SUBJECT: Forwards addl info re 830701 submittal on testing of Superstrut matl, per NRC request. Analysis utilizing point estimate/tenth percentile criteria, provided in util 830701 submittal, gives acceptable results.

Re: Docket No. 50-275, OL-DPR-76
Docket No. 50-323
Diablo Canyon Unit 1 and 2
"Superstrut" Evaluation Additional Information

Additional Information for "Superstrut" Evaluation

FIGURE 3-1 CRITERIA STRENGTH IN TERMS OF THE NUMBER OF STANDARD DEVIATIONS BELOW THE AVERAGE

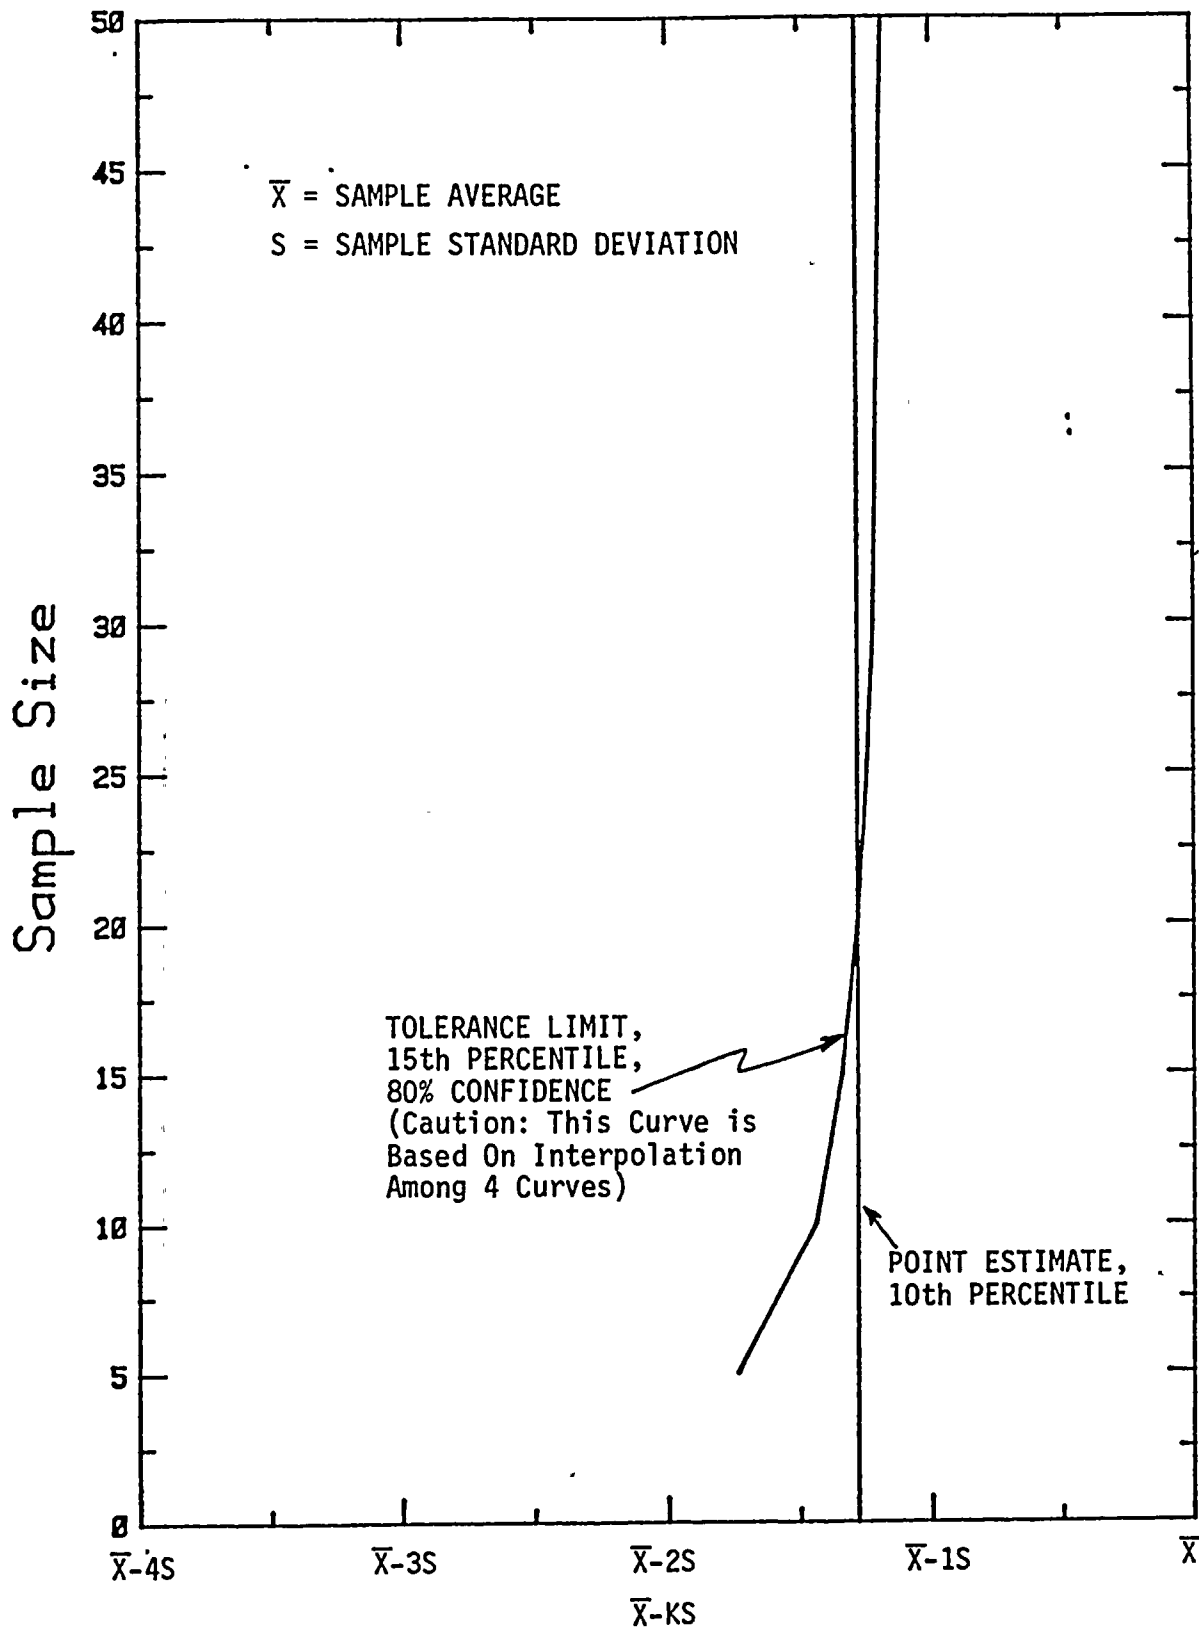
The Diablo Canyon criteria for spotweld shear strength was based on the point estimate, tenth percentile value, which is approximately 1.28 standard deviations below the sample average (assuming a normal distribution). The criteria based on the tolerance limit, fifteenth percentile, 80 percent confidence level (i.e., there is a probability of 0.80 that at least 85 percent of the population is greater than this limit) depends on the sample size. The relationship between sample size and the above tolerance limit for a normal distribution are shown in Figure 3-1. Figure 3-1 is a plot of the sample size versus the tolerance limit criteria which is in terms of the number of standard deviations below the sample average. In other words, if

the sample size were five, the tolerance limit criteria would be about 1.74 standard deviations below the sample average. If the sample size were 50, the tolerance limit criteria would be about 1.18 standard deviations below the sample average.

Superimposed on this plot, Figure 3-1, is the 1.28 standard deviations corresponding to the point estimate, tenth percentile value used by PGandE in the results provided in the July 1, 1983 submittal. The intersection of these two curves identifies where the two approaches yield equal criteria. The point of intersection also indicates the number of samples which would be needed to make the two criteria equal. If the actual sample size is larger than this number, the point estimate, tenth percentile criteria is more conservative than the tolerance limit, fifteenth percentile, 80 percent confidence level criteria. As shown on Figure 3-1, the critical sample size is about 20*. Both the E and combined A and H type group sample sizes are greater than this value. Therefore, the point estimate, tenth percentile criteria, is at least equal to the tolerance limit, fifteenth percentile, 80 percent confidence criteria.

In conclusion, the method of analyzing Superstrut channels (point estimate, tenth percentile criteria), provided in PGandE July 1, 1983 submittal, gives acceptable results. This is further corroborated by comparison to results obtained by the tolerance method, which was suggested by the NRC Staff. Comparison of these results is provided in Table 3.1.
